FINAL REVIEW OF NORTHMET MINE SITE MODFLOW MODEL

*NORTH ATLANTIC DIVISION REGIONAL CENTER OF EXPERTISE FOR GROUNDWATER
MODELING*

PHILADELPHIA DISTRICT, US ARMY CORPS OF ENGINEERS

AUGUST 2016

Figure 8

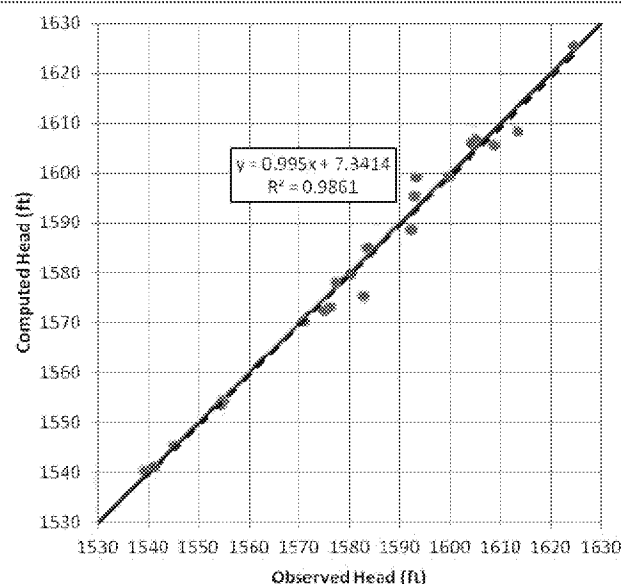
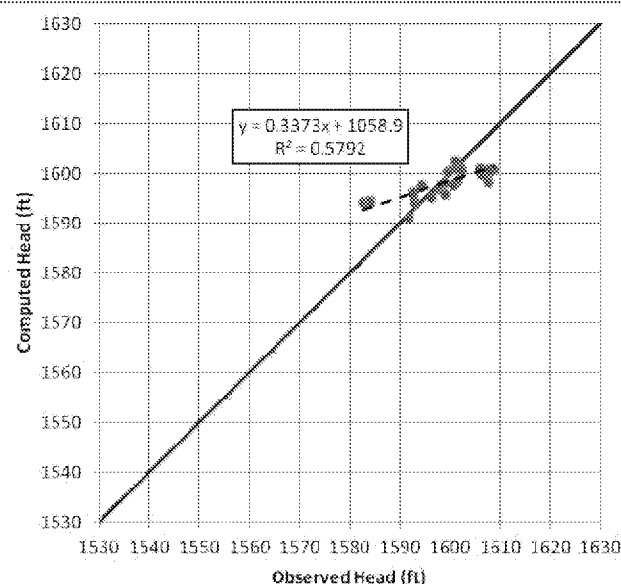
The comparison of observed and computed heads in the unconsolidated deposits (layer 1) shows a very good agreement. When computed and observed values at each observation point are plotted as shown on the left side of Figure 8, the slope is 0.995, very close to the optimal 1.0. The use of pilot points to define the horizontal hydraulic conductivity has allowed for the heterogeneity required to closely reproduce the measured heads.

The comparison of observed and computed heads in the bedrock (assumed layer 2) is not as close, as shown in the right plot on Figure 8. The range of measured heads is smaller, so most wells match within a few feet, but when computed and observed values at each observation point are plotted, the slope is 0.337 indicating that the head change across the site in the bedrock is about 3 times that calculated in the model.
